SUBJECT: ISSUANCE OF AMENDMENT NO. 9 TO FACILITY OPERATING LICENSE NO.  
NPF-74 FOR THE PALO VERDE NUCLEAR GENERATING STATION, UNIT 3  
(TAC NO. 67865)

PALO VERDE NUCLEAR GENERATING STATION, UNIT NO. 3

Amendment No. 9  
License No. NPF-74

SAFETY EVALUATION BY THE OFFICE OF NUCLEAR REACTOR REGULATION  
RELATED TO AMENDMENT NO. 9 TO FACILITY OPERATING LICENSE NO. NPF-74,  
ARIZONA PUBLIC SERVICE COMPANY, ET. AL.  
PALO VERDE NUCLEAR GENERATING STATION, UNIT NO. 3

FIGURE 3.1-1  
ALLOWABLE MTC MODES 1 AND 2  
PALO VERDE UNIT 3 CYCLE 1

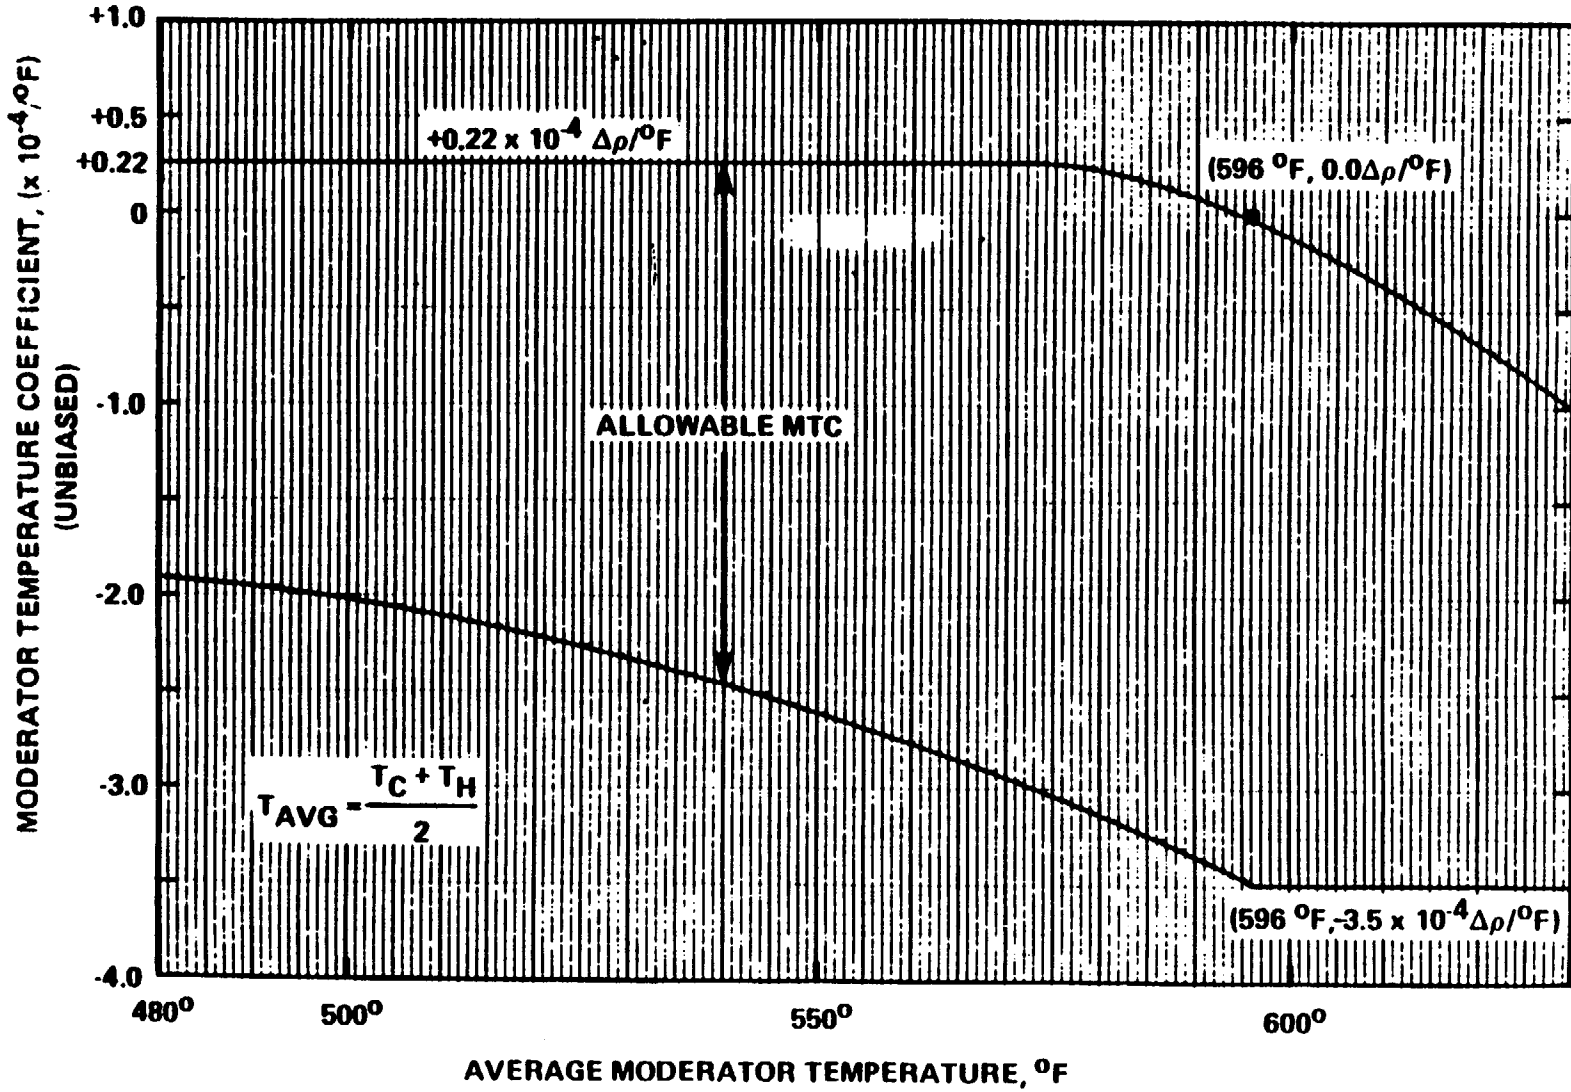
The Amendment revises the Technical Specifications for Palo Verde Unit 3, as follows. Technical Specification 3/4.1.1.3 provides limits on the Moderator Temperature Coefficient (MTC). The Amendment revises Figure 3.1-1 to increase the negative MTC limit from -30 pcm/°F to -35 pcm/°F.

The TS limit on MTC was determined from the CE System 80 steam line break analysis. In the analysis, an assumed moderator reactivity versus coolant temperature function was applied using the most negative (including uncertainties) technical specification moderator temperature coefficient of  $-35 \text{ pcm}/^{\circ}\text{F}$  at nominal full power conditions,  $T_{\text{avg}} = 594^{\circ}\text{F}$ .

The current MTC limit of -30 pcm/°F in the Unit 3 TS was required to compensate for the as-built safety injection drain line configuration. Subsequently the drain lines were reconfigured so that the MTC limit of -35 pcm/°F that was assumed in the safety analyses would be valid.

Based on the above, the staff concludes that the proposed change to Specification 3/4.1.1.3 is acceptable.
